PLANNING, ZONING, & BUILDING DEPARTMENT  
PZ&B Staff Memorandum: Landmarks Preservation Commission

SUBJECT: HSB-24-0002 211 PARK AVENUE

MEETING: AUGUST 21, 2024, LPC

**HSB-24-0002 211 PARK AVE.** The applicant, Jonas Heidrich, has filed an application requesting the review and approval of window and door replacement, the addition of new window and door openings, roof replacement, installation of exterior detailing, landscaping, and hardscape modifications.

1 PROPOSED SOUTH ELEVATION

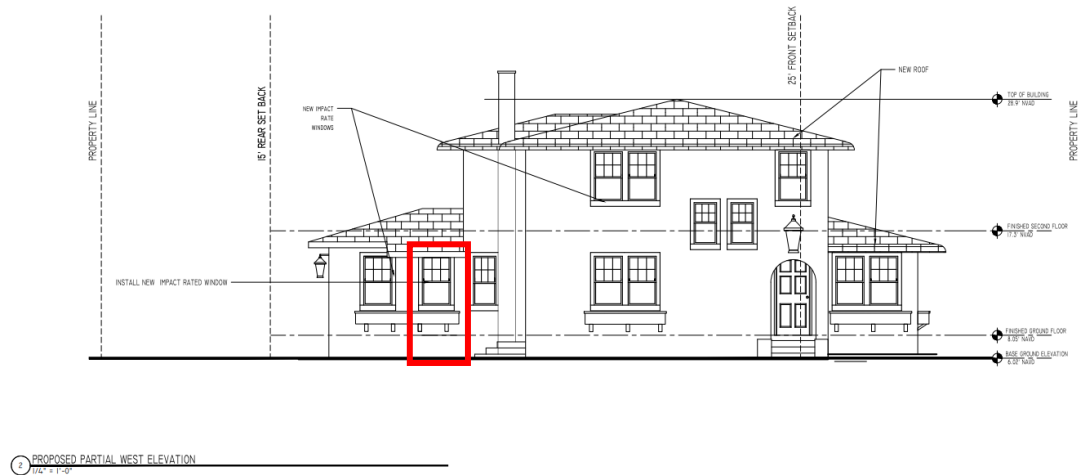
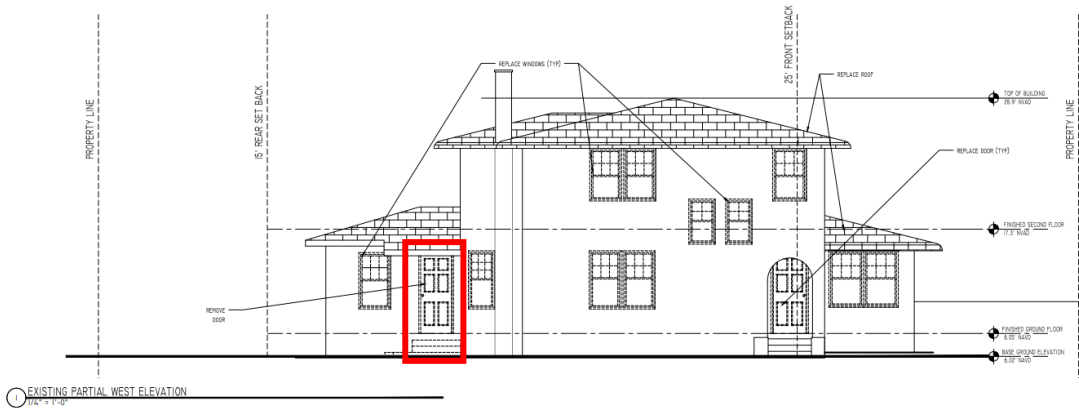
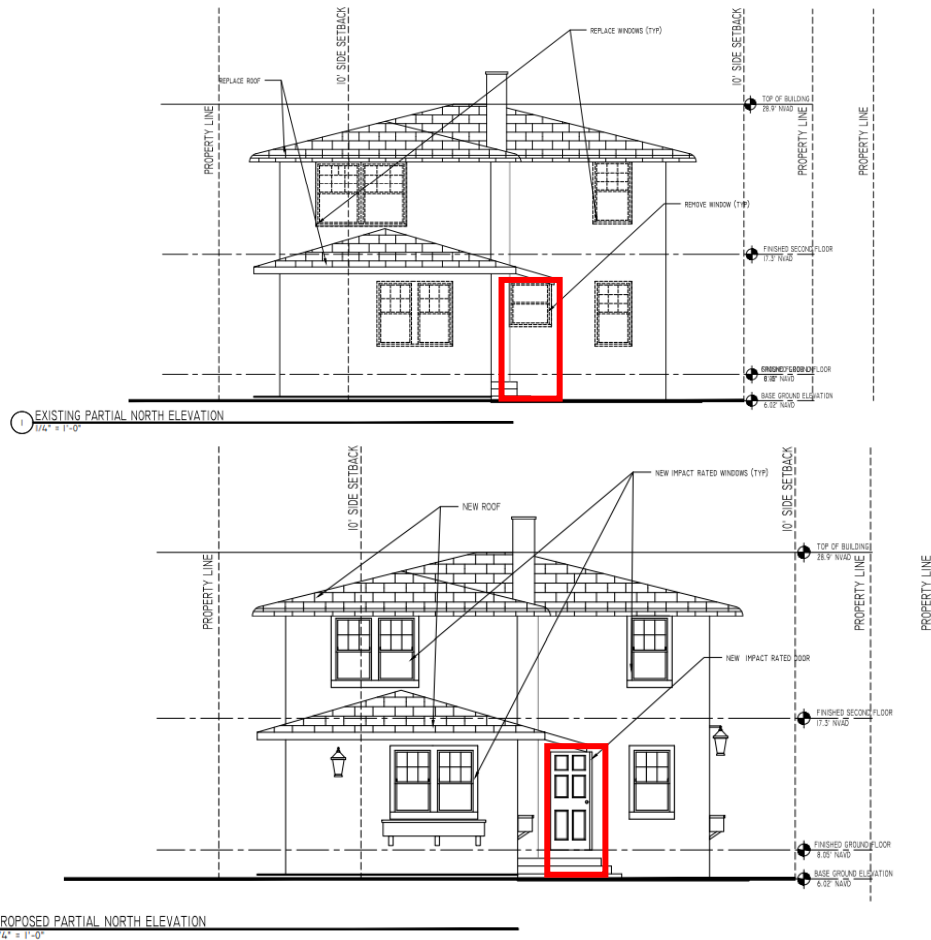
The new aluminum-framed windows will feature 6/1 divided-light patterns, adjusted to 4/1 or 8/1 for varying window widths. There is only one remaining historic window and that has been the inspiration for the lite pattern. The frames will have a light green color as depicted on sheet A-017 of the plans. The proposal also seeks to add trim and sill details to the windows.

New asphalt shingles in the “aspen gray” color are proposed to replace the existing asphalt shingles. The application also seeks to re-stucco and repaint the residence in accordance with the color scheme depicted on sheet A-017.

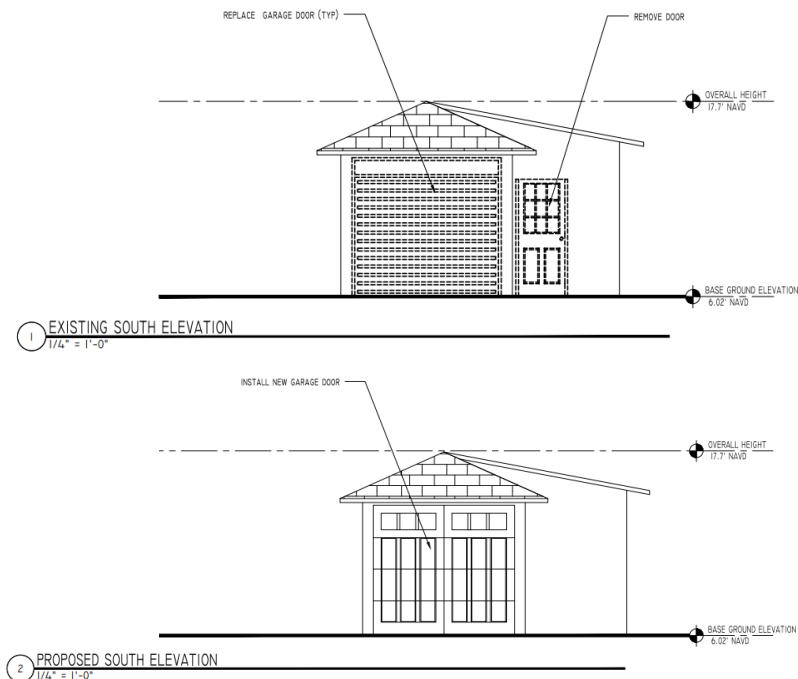
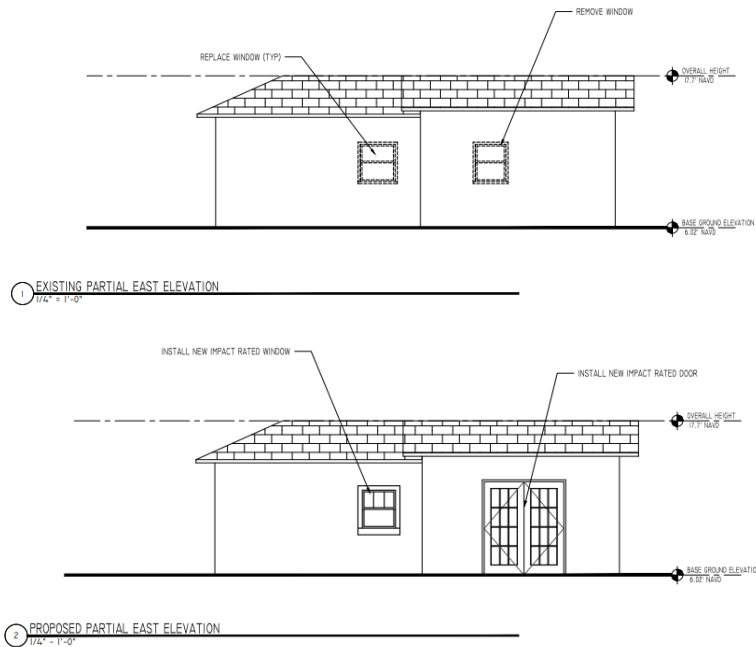
On the west elevation, a door opening will be replaced with a window on the first floor. On the north elevation, a door opening will be replaced with a window on the first floor. On the east elevation, a window opening will be added on the first floor.
